QUESTIONS & ANSWERS #3

WQCF Sludge Thickener and Dewatering Unit No. 3 Project CIP 24006 & 24007

Q.3.17. WQCF Sludge Thickener...Bid Set Plans RED:  
Drawing No. 07D501 and 07M501

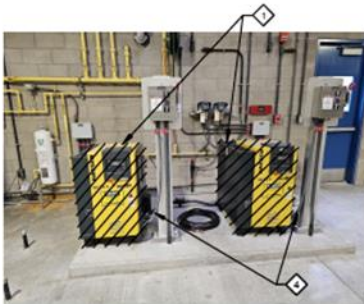
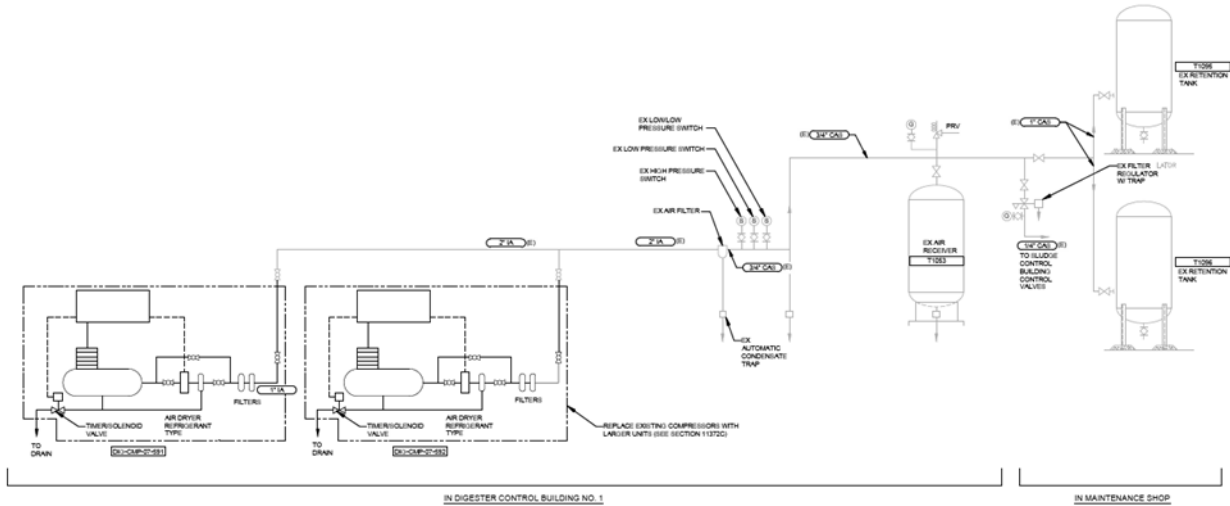
These pages suggest replacing old compressors with new compressors in the same location, but where would the separate dryers and tanks be located?

A.3.17. Refer to Q&A 3.10 and 3.11.
